RE: LFPCN 41357 - Littelfuse TVS DO-214AB Package Lead Frame Optimization

Product/Pro	cess Change Notice (PCN)			
PCN#: LFPCN #41357	Date: Aug 25 th , 2020	Contact Information			
Product Identification:		Name: Jennv Chen			
TVS STD DO-214AB SMC	package				
Implementation Date for Ch					
Dec 25 th , 2020 or sooner	J				
20020 ; 2020 01 0001101					
Category of Change:	Descri	otion of Change:			
Assembly Process	Littelfus	se TVS DO-214AB Package Lead Frame Optimization for much better			
Data Sheet	quality	and reliability of TVS Diodes.			
Technology					
Discontinuance/Obsolescence	9				
Equipment					
Manufacturing Site					
Raw Material					
Testing					
Fabrication Process					
Other:					
Important Dates:					
Qualification Samples A	Available: Available up	oon the request Last Time Buy:			
Final Qualification Data Available:					
☑ Date of Final Product Shipment: Dec 25 th , 2020					
Method of Distinguishing	Changed Product				
Product Mark,					
Date Code,					
Other,					
Demonstrated or Anticipa	ated Impact on Form,	Fit, Function or Reliability:

Prepared By	: Hellen Yang
Date	: 8/18/2020
Device	: DO-214AB Leadframe molding lock & V groove optimization
Revision	: A

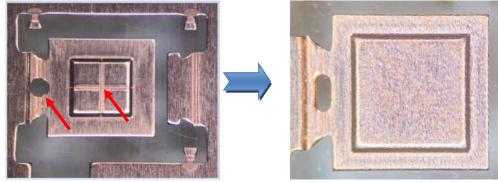
The purpose of this project is to qualify DO-214AB TVS with optimized leadframe mold lock design &remove V groove to reduce trim &form stress and soldering stress. Succeeding pages summarize the material and reliability test performed in qualification lots.

New

There is no change in mechanical specification or package outline dimension (POD).
